# UNITED STATES PATENT AND TRADEMARK OFFICE

| APPLICATION NO.  | FILING DATE | FIRST NAMED INVENTOR | ATTORNEY DOCKET NO. | CONFIRMATION NO. |
|--|-------------|----------------------|---------------------|------------------|
| 10/824,894   | 04/15/2004  | Michael J. Pratt     | 12073.5             | 7574             |

| <b>Office Action Summary</b> | Application No.<br>10/824,894 | Applicant(s)<br>PRATT ET AL. |  |

## DETAILED ACTION

Wade, Figure 4

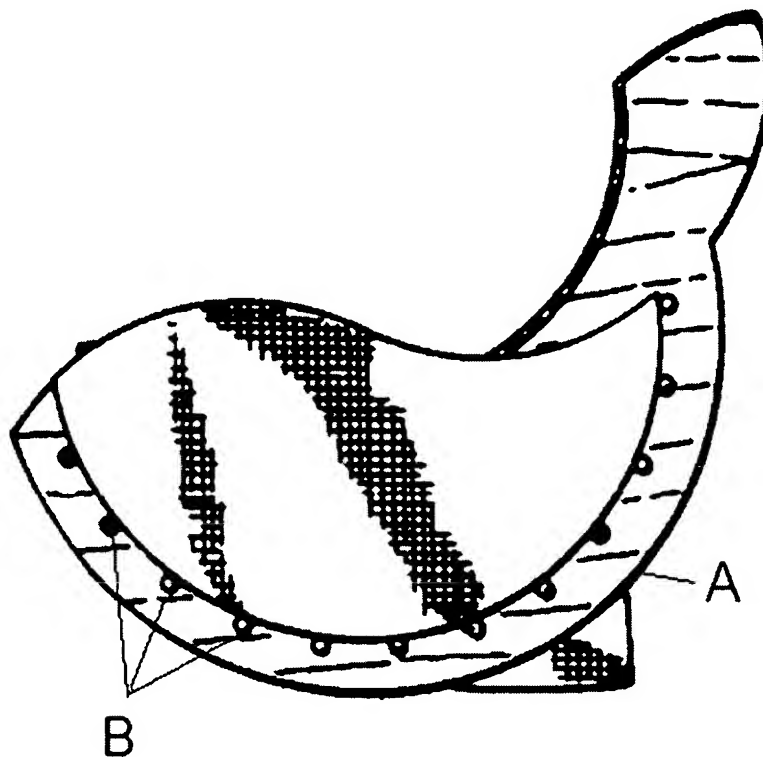
14. Claims 9 and 10 are rejected under 35 U.S.C. 103(a) as being unpatentable over Landry as applied to Claim 8 above in view of Wade in US Patent D315643. Landry fails to teach traction elements on the contact surface. Wade teaches a chair with a contact surface (A) having traction elements comprising teeth (B) that are integral to the rocking surface (insofar as the applicant shows teeth on the rocking surface). It would have

been obvious to one of ordinary skill in the art at the time of invention to modify the rocking surface of Landry by adding teeth in order to increase the grip the rocking surface has on a slippery surface.
